**RE: CRAVENS RESIDENCE, LOT 13, BLOCK 2, TRACT 2, UNIT 1, NAA (C22-D31)  
(PWD 96-77), ENGINEER'S STAMP DATED 12/4/96.**

The purpose of this letter is to clarify some of the previous comments made by the County, AMAFCA and myself regarding the above referenced property. The main issue is the amount of runoff in the arroyo that should be used for design.

RE: CRAVENS RESIDENCE, LOT 13, BLOCK 2, TRACT 2, UNIT 1, NAA (C22-D31) (PWD 96-77) SUBMITTED FOR BUILDING PERMIT APPROVAL, ENGINEER'S STAMP DATED 5/3/96.

PROJECT LOT DEVELOPMENT PLAN FOR DAN CRAVENS

TITLE SITE, GRADING AND DRAINAGE

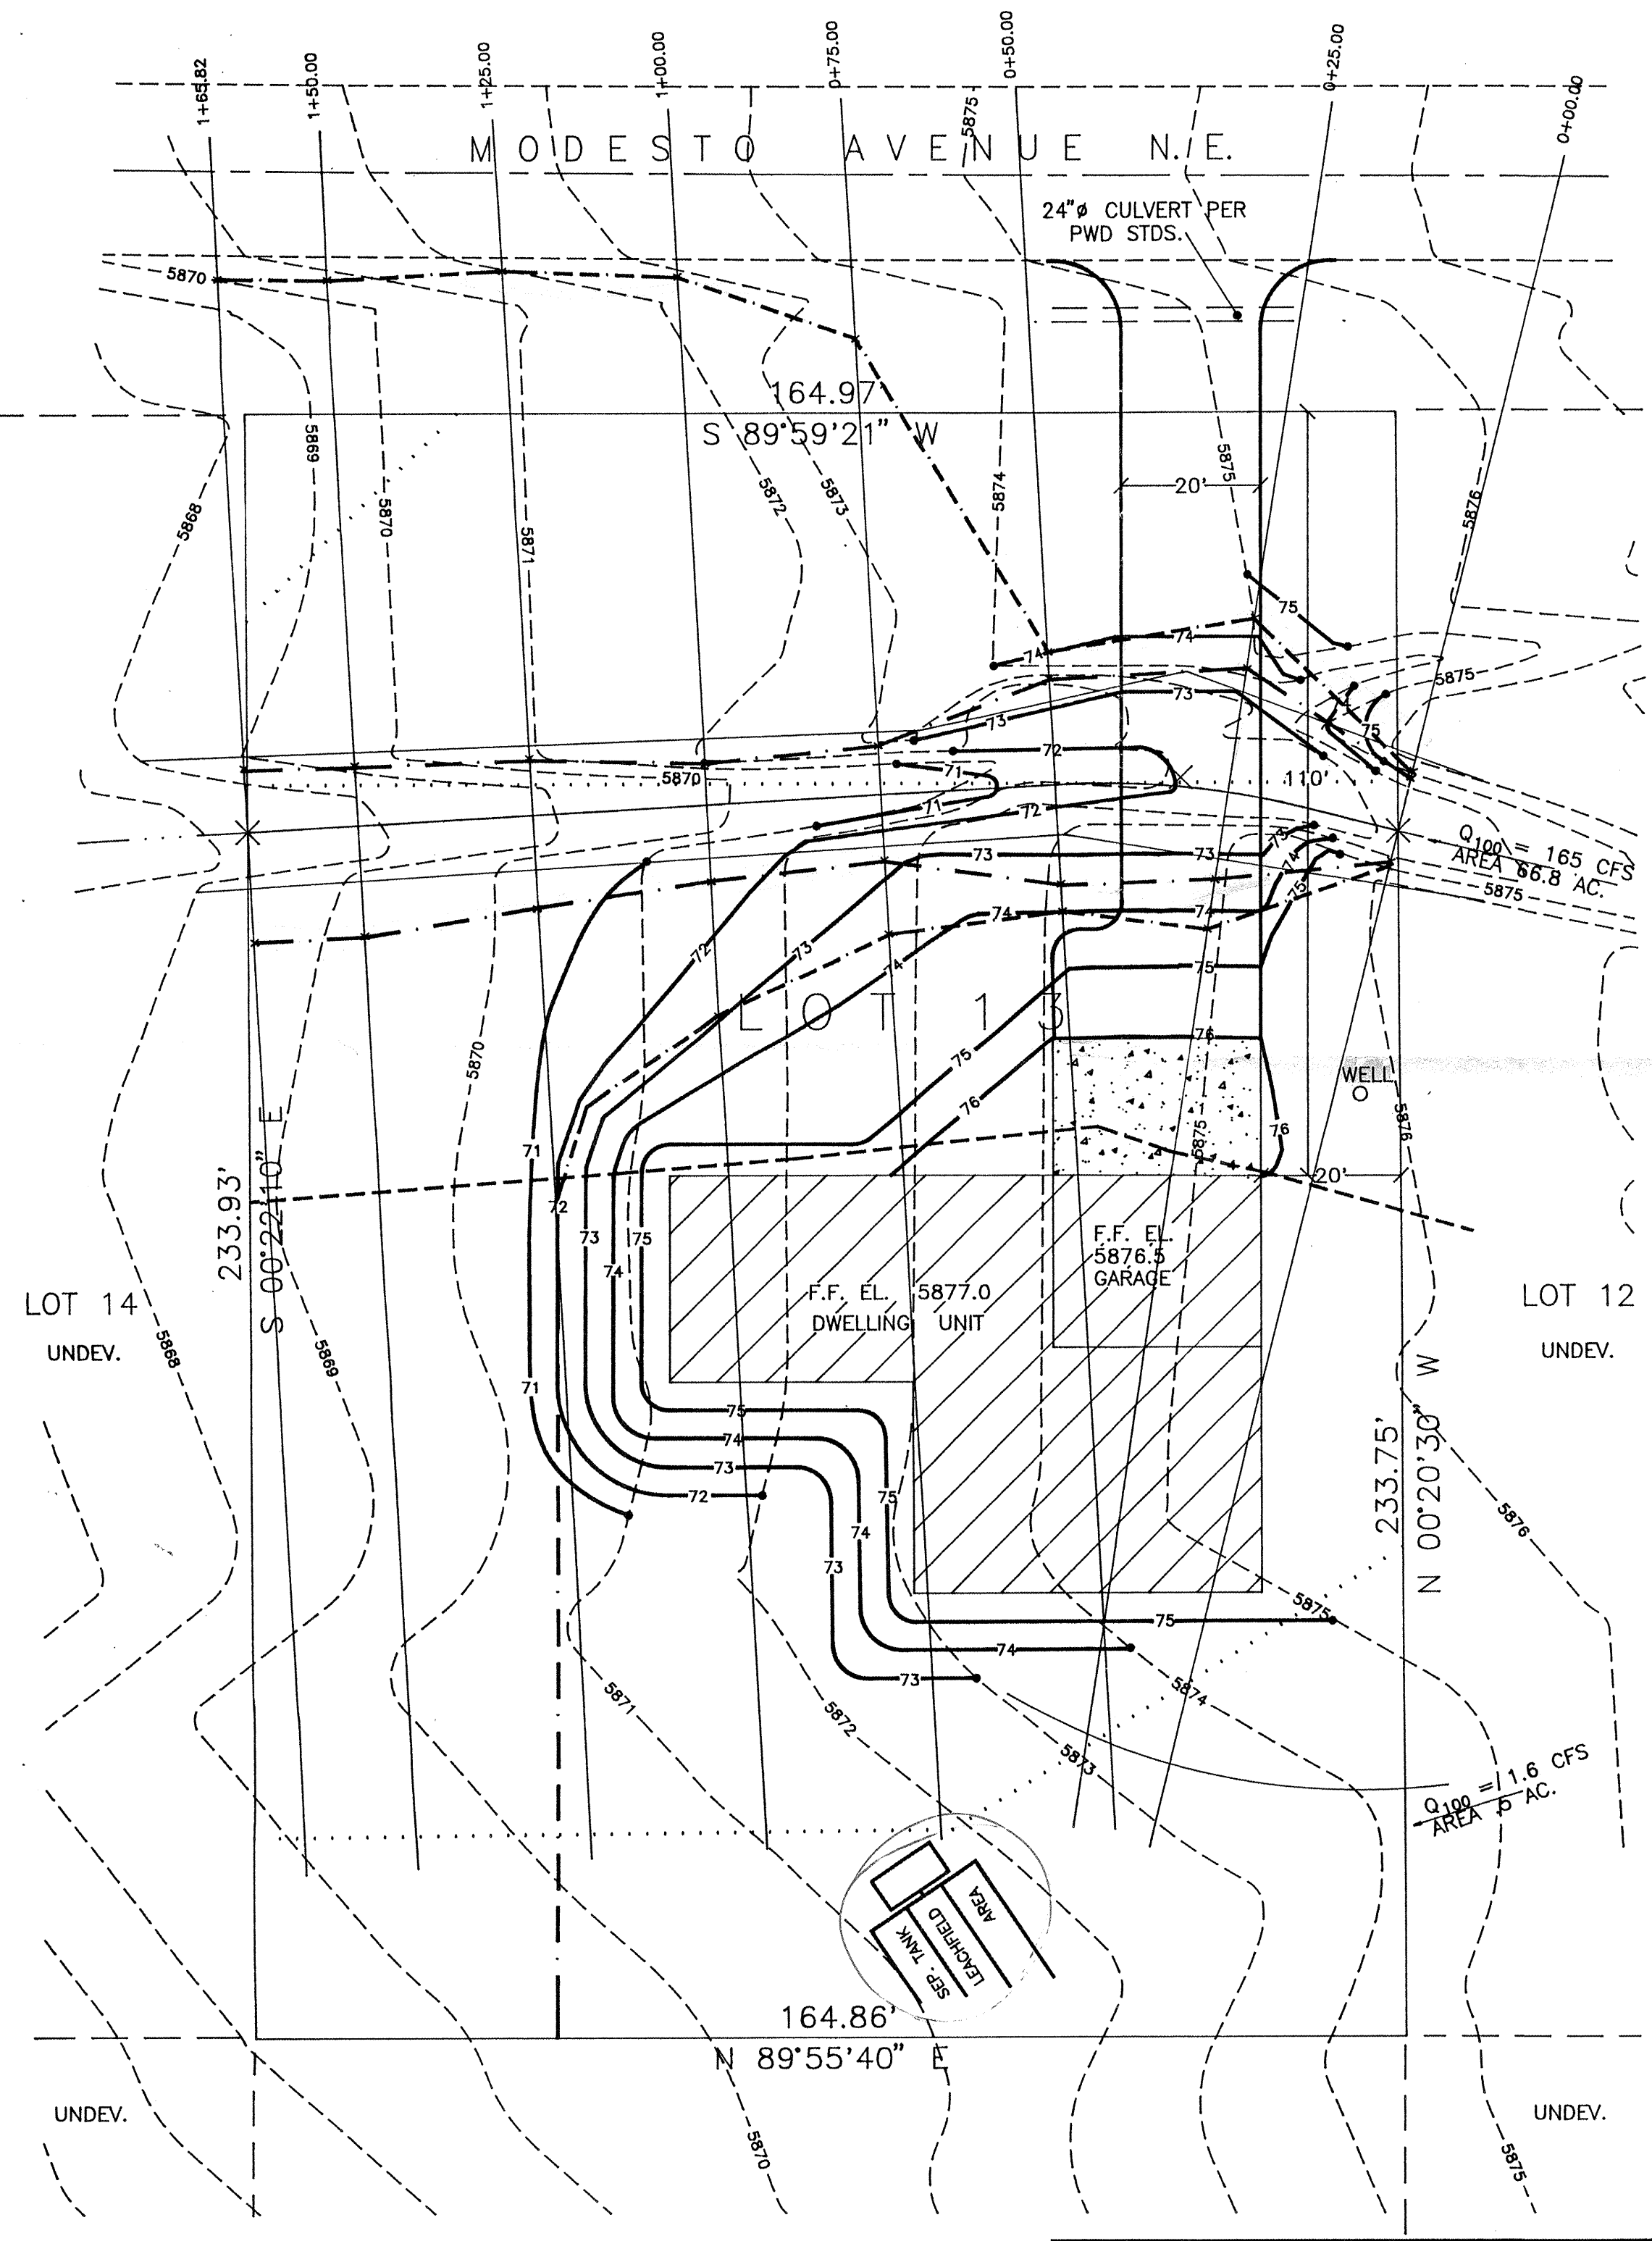
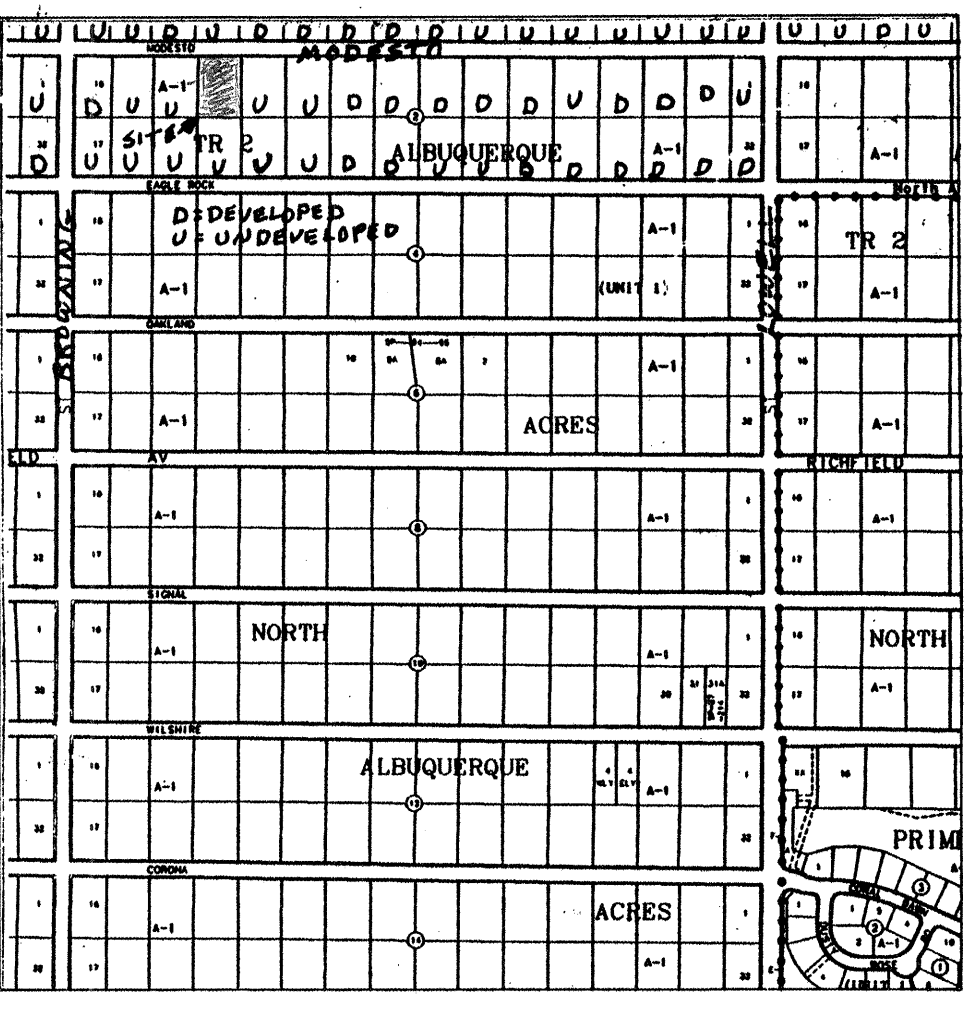
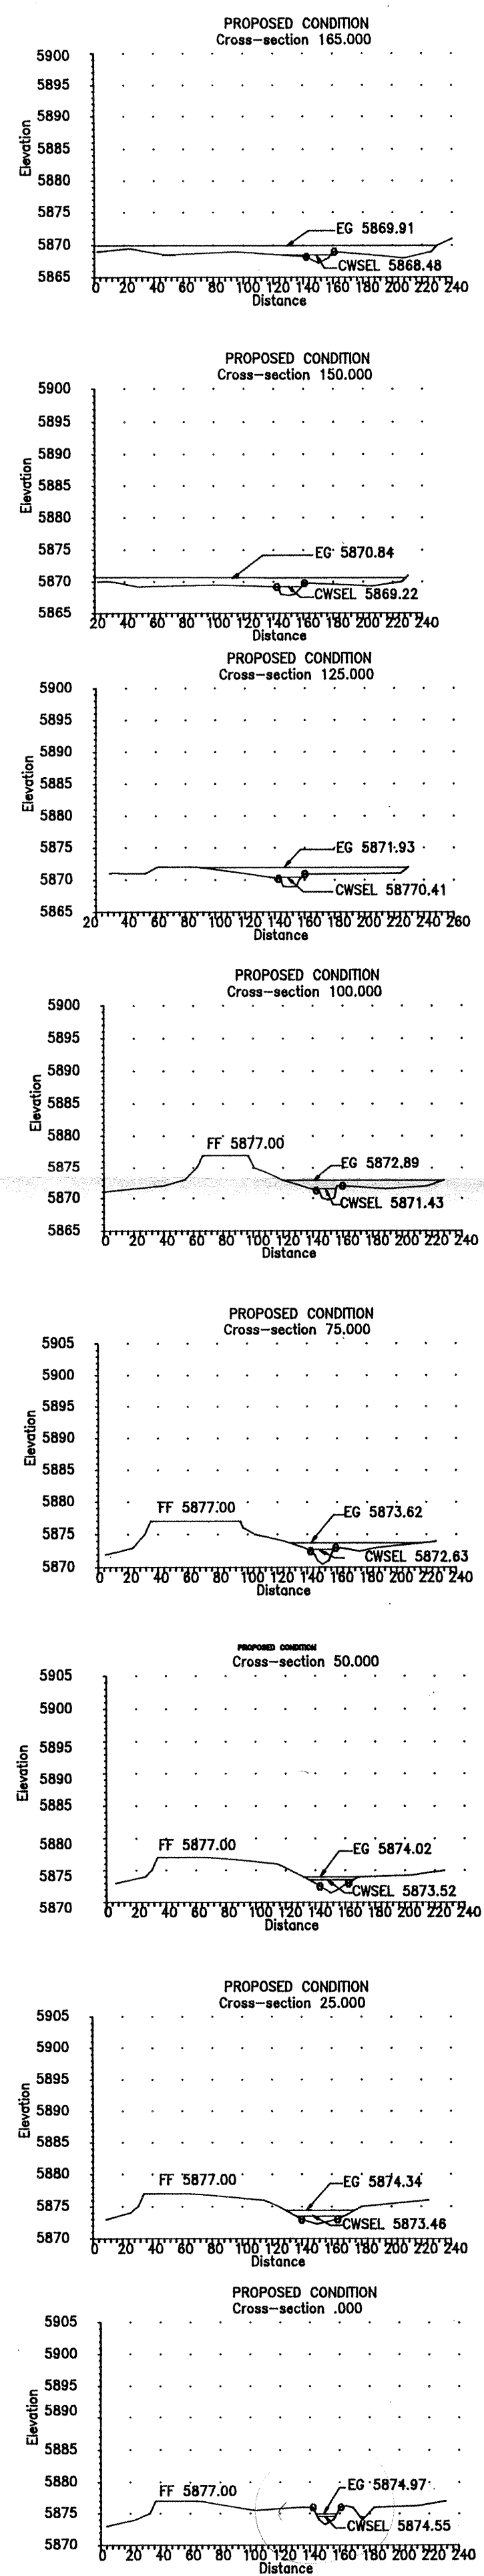
Recent studies by Resource Technology, Inc. have identified the avulsion upstream of this site and determined that at least 800 cfs may be carried in the arroyo through this lot. Therefore, since the County and AMAFCA have no plans to construct improvements to remove this avulsion at this time, 800 cfs should be used in your design.

Using the flow of 800 cfs, show the limits of the HGL and EGL on the plan. The erosion setback (ESB) must be calculated using AMAFCA's Sediment and Erosion Design Guide for this Q. The ESB should be plotted on the plan. Please use the formula in the DPM for calculating the freeboard. The finish floor elevation should be placed at a least as high as the EGL plus freeboard.

The limits of the existing FEMA floodplain must also be shown on the plan. Since the easement will be based on this floodplain, an encroachment license will be required for most of the construction on this lot.

1. The limits of the existing FEMA floodplain must be shown on the plan. It appears that the floodplain encroaches on most of this lot. Grading will be allowed within the floodplain if the analysis shows that the grading will not adversely affect any adjacent properties. If the proposed improvements change the floodplain, a Letter of Map Revision from FEMA will be required.

2. The calculated flow of 165 cfs is low for this arroyo. There are approved grading and drainage plans just downstream of this lot which use 400 to 500 cfs (one plan was prepared by you). There is also a recent study by RTI which may be referenced. That study indicates that there is an avulsion upstream. This must be addressed.

3. An easement will be required for the area within the existing floodplain, or the EGL, whichever is larger. Encroachment agreements will be required for any development within the easement. As you are aware, the easement must be on file at AMAFCA prior to plan approval.

4. All off-site drainage basins must be delineated on the plan. Calculations for the  $t_c$  is also required.
5. Typically the finish floor elevation is set at EGL plus freeboard. Please calculate the freeboard to see if the 2' is adequate.

6. Please plot the HGL and EGL for the arroyo under existing conditions (prior to grading). This will be compared to the HGL and EGL for the proposed grading. The HEC-2 input and output data should be provided for both conditions. Also show where the cross-sections are located.

7. The erosion setback (ESB) must be calculated using AMAFCA's Sediment and Erosion Design Guide. The ESB should be plotted on the plan.
8. Show the proposed well location on the plan. The location of the septic system is in violation of County Ordinance 88-1 with respect to distances from arroyos.

9. The plan describes the driveway as paved and graveled. Which treatment is proposed? Was this taken into account in the HEC-2 analysis?
10. The on-site hydrology accounts for too much land treatment A. The plan shows a large disturbed area around the residence. A note should be added to the plan addressing revegetation of the disturbed area.

11. There is a defined swale along Modesto. How will this be mitigated?
